TO:	City of Gainesville Development Review Board	Item #:2
FROM:	Department of Doing	Date: 3/28/2017

SUBJECT:	<u>Petition DB-17-005 SPA.</u> EDA, Inc., agent for Exactech, owner. Major development plan review to allow expansion of an existing building and construction of a three-story parking structure. Zoned: I-1 (Limited Industrial District). Located at 2321 NW 66th Court.
-----------------	---

Map: 1.
Exactech Site Plan and Areas of Expansion

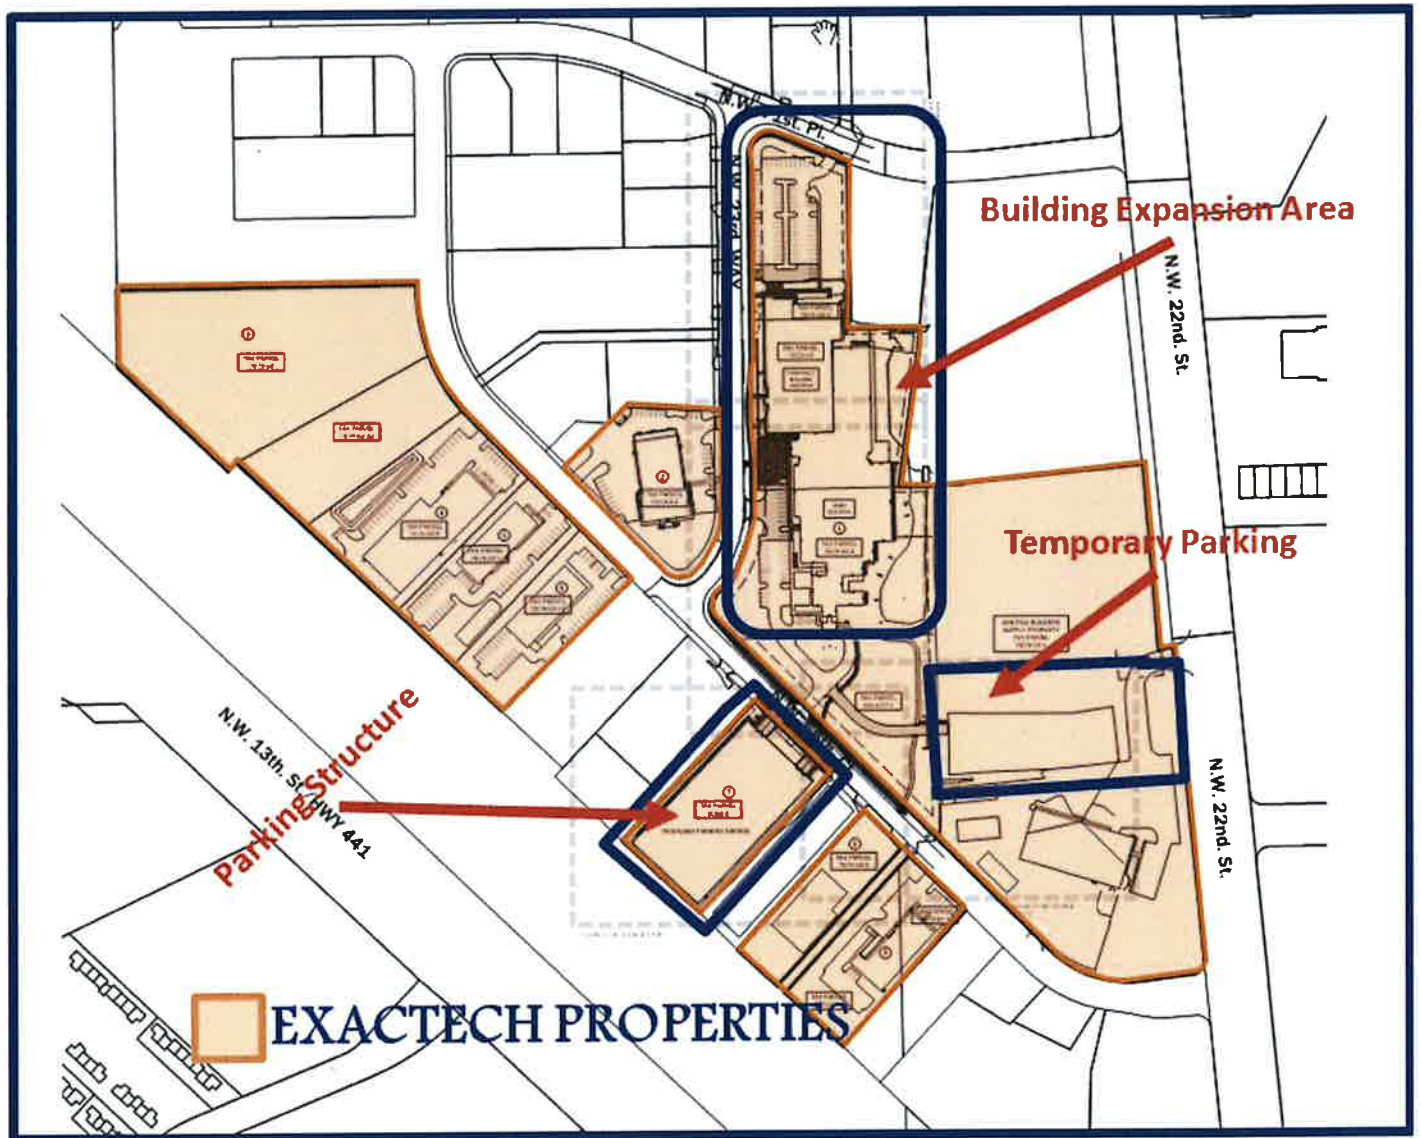
The development site and proposed expansions, as depicted in Map 2 below, are regulated by the local zoning district standards, the Wellfield District, and other regulations associated with the provision of off-street parking, landscaping, environmental concerns, stormwater management and site lighting.

The properties are regulated by two zoning districts, I-1 and I-2 which have similar development standards except for the side setback which is 20 feet in the I-2 District as opposed to 10 feet in the I-1 district. The proposed development complies with the industrial district standards except for the 20-foot side setback on one lot in the I-2 district where the parking structure is proposed. The parking structure which is located on one of the isolated lots on the west side of the development is not able to meet the 20-foot side setback and

was granted a variance by the Board of Adjustment to allow a reduced setback of 10 feet, similar to the side setback of the I-1 district.
